Addendum to the  
Planning Report

**NISA**  
*North Irish Sea Array*

# Planning Report

Figure A2.1 Infrastructure of the proposed development – not to scale (Source: Arup) (Replacing Figure 2.1 of the 2024 Planning Report)

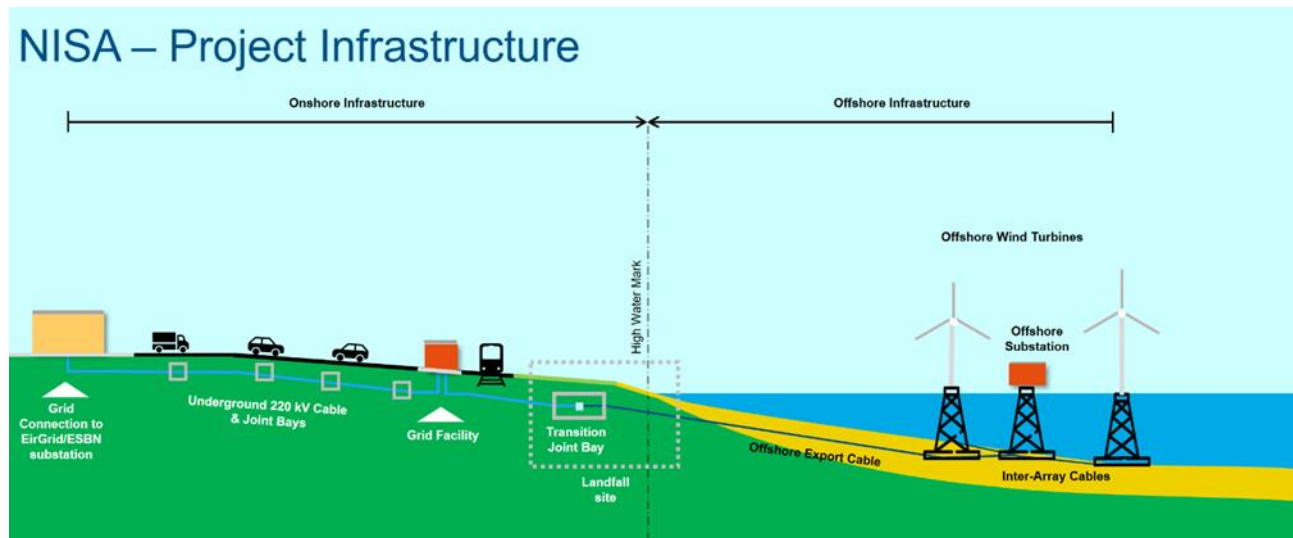
The only change required to Section 2.1 of the 2024 Planning Report is in relation to Figure 2.1. The figure, which presented wind turbine generators (WTGs) with monopiles, has been updated to show the WTGs with jacket substructures and suction bucket foundations and to remove the previous depiction of an ownership boundary, as this aspect is not relevant to the graphical illustration of the proposed development.

For the purposes of clarity, Figure 2.1 from the 2024 Planning Report shall be deleted and replaced with Figure A2.1.
